SERVICE BULLETIN		
To: For the attention of: Please copy to:	All Dealers Service Manager/After Sales Manager The Dealer Principal The Warranty Supervisor Aston Martin Technician(s) The Parts Manager	Reference SB0283 Issued: 03rd February 2009 Page 1 of 10
Model:	V8 Vantage, Coupe and Roadster DB9, Coupe and Volante DBS	
VIN Range:	All	
Subject:	Satellite Navigation Display Screen, Repair to the Transport Mechanism

Figure 1

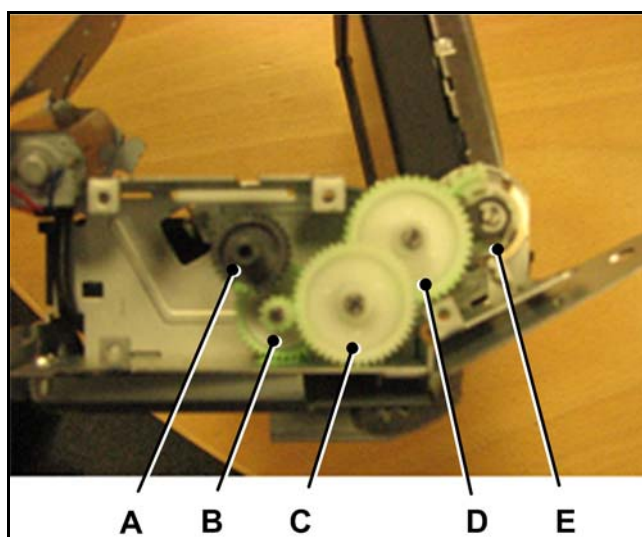
There have been some occurrences where the Satellite Navigation (Sat Nav) display screen will not move. The cause has been identified as Gear E in the transport mechanism (see Figure 1). The manufacturer of the system has released a repair kit to install a new Gear D and a new Gear E. Follow the Workshop Procedure to do the repair.

Figure 12

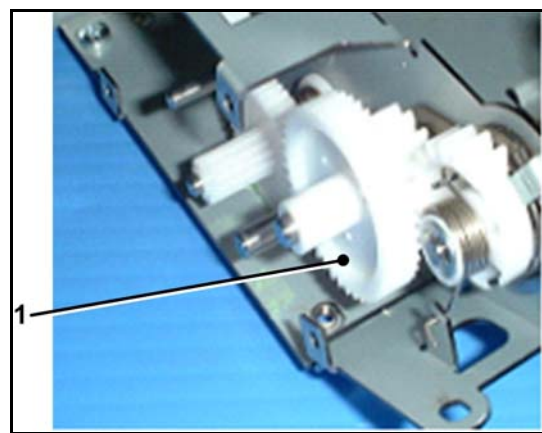
14. Pull Gear D off of its spindle to remove it (see Figure 12). Discard Gear D.

Figure 16

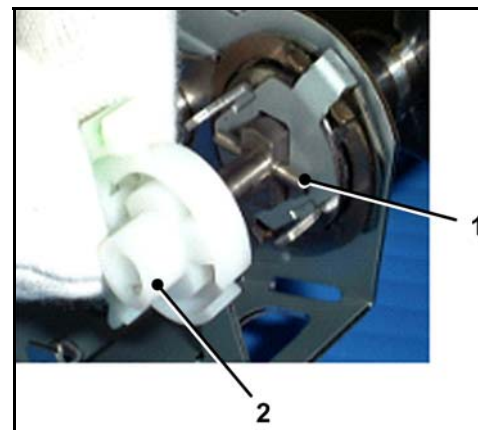
19. Pull Gear E (2) off of its spindle. Do not move or lose the drive pin (1) (see Figure 16). Discard Gear E.

Figure 18

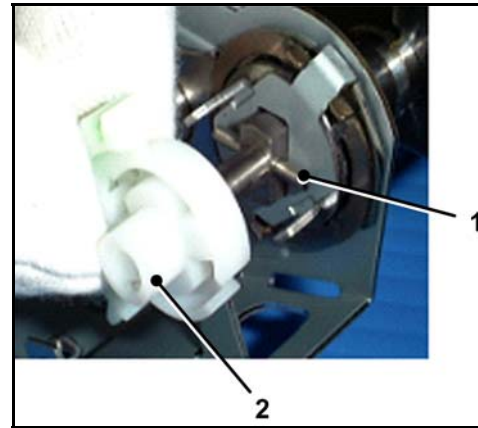
22. Put the new Gear E on to the spindle. Make sure that the drive pin (1) is correctly aligned.

Figure 21

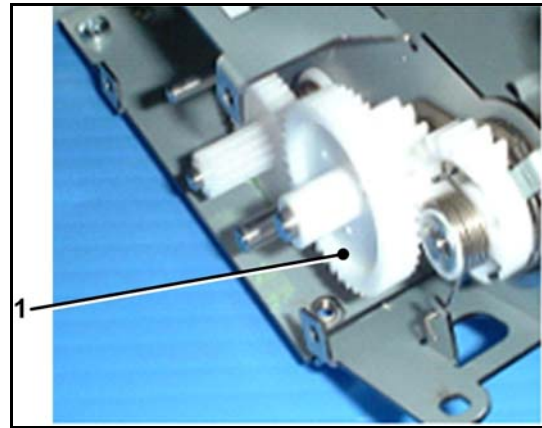
28. Install the new Gear D on to its spindle (see Figure 21). Make sure that the teeth on the small gear wheel engage correctly with Gear E.
